**Comment Response Document (CRD)
to Notice of Proposed Amendment (NPA) 04-2006**

**for amending the Executive Director Decision No. 2006/05/R
on certification specifications, including airworthiness codes and acceptable means of
compliance, for large aeroplanes (« CS-25 »)**

**Symbolic Exit Signs And
Revised Standards for Cargo Compartments (D To C)**

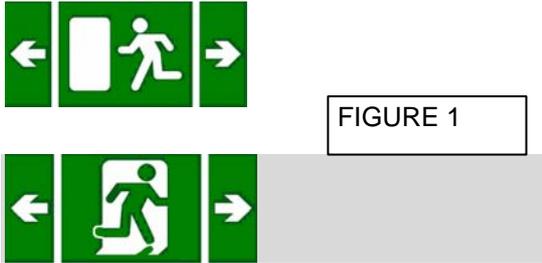
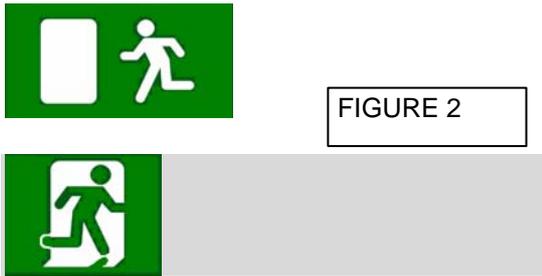
10.	JAA NPA 25D-327 AMC 25.811(e)	FAA	<p>We have not seen any data supporting the use of the symbol shown for the floor proximity exit marking sign given as an acceptable example in this paragraph. Given the difficulties evident in the responses to signs with vertically oriented arrows in the Cranfield study, we recommend that text based signs be required in this application, or that the same symbol accepted as complying with 25.811(d)(1) be used here also.</p> <p>Justification: Data aren’t present to support the use of the symbol shown.</p>	<p>Accepted The justification given by the JAA CSSG for choosing the “arrow” symbol was primarily related to the small size of these signs and the need to provide the greatest amount of general illumination from the white portions of the sign.</p> <p>EASA specialists have reviewed the use of this symbol and concur with the commenter that its use could be problematic and that the need for general illumination could be achieved by other means.</p> <p>Furthermore, in reviewing the symbology used for other signs, it was clear that they did not reflect the latest international standards. Alternative symbols that are deemed to have equivalent safety and which would be acceptable to EASA are added to AMC 25.812(b)(1) and AMC 25.812(e)(2).</p>	See Annex 1 below

#	Para	Comment provider	Comment / Justification	Response	Resulting text
			<p>administered methods has on the validity/reliability/consistency of the results.</p> <p>– It is not clear how the variables “nationality/region”, “previous exposure” and “frequency of air travel” were ‘isolated’ in the analysis (to ensure their independency) (ref. para. 2.7).</p> <p>– It is noted that the degree of comprehension of graphical exit signs by region shows that for (presumably) non-English speaking people (to whom such signs are mostly directed...) was, in some cases, lower than that for language signs; it is not clear what caused this phenomenon.</p> <p>Accordingly, TCCA cannot conclude (from the available data) that symbolic exit signs, as proposed, offer a level of safety equivalent to that of the required text signs in emergency evacuation conditions. TCCA is aware of work currently under way by the FAA to assess the comprehensibility (and “confusability”) performance of graphical exit signs, as well as to define activities needed to move towards their implementation. It is anticipated that this work will provide answers to many outstanding questions and concerns.</p> <p>In case, EASA decides to proceed with final rulemaking per this proposal, it is TCCA’s recommendation that EASA should consider retaining “EXIT” sign specifications in relevant rules (rather than being incorporated in a guidance document). Any time a minimum level of safety requirement is not specified in the rules If the requirements that define a minimum level of safety are not specified in the rules, it can potentially lead to its inadequate and inconsistent implementation.</p>	<p>investigated this further (see below).</p> <p>Further analysis of these factors was undertaken in Phase 2 of the study (Para 3). “Region of Origin” was determined as being mildly influential and was equally valid for both symbolic and language based signs. “Previous Exposure” and “Frequency of Air Travel” were not significant.</p> <p>The phenomenon is explained on the lack of contextual cues associated with the photographs. It is noted however, that, based on the 66% pass criteria, more regions pass the criteria with symbolic signs (5/8) as opposed to language based signs (4/8).</p> <p>EASA has determined that sufficient evidence exists that symbolic signs provide at least an equivalent level of safety compared with conventional signs and are readily recognised and understood by a multinational general and travelling population. (See also response to Comment 6).</p> <p>(See response to Comment #8)</p>

ANNEX 1: CHANGE TO AMC MATERIAL TO ILLUSTRATE SYMBOLIC SIGN DESIGNS ACCEPTABLE TO EASA

Examples of acceptable designs of symbolic exit signs

<p><u>CS 25.811(d)(1)</u> (exit locator sign)</p>	 <p>FIGURE 1</p>
<p><u>CS 25.811(d)(2)</u> (exit marking sign)</p>	 <p>FIGURE 2</p>
<p><u>CS 25.811(d)(3)</u> (exit sign on bulkhead or divider)</p>	 <p>FIGURE 3</p>

The design of symbolic exit signs should be chosen to provide a consistent set throughout the cabin.
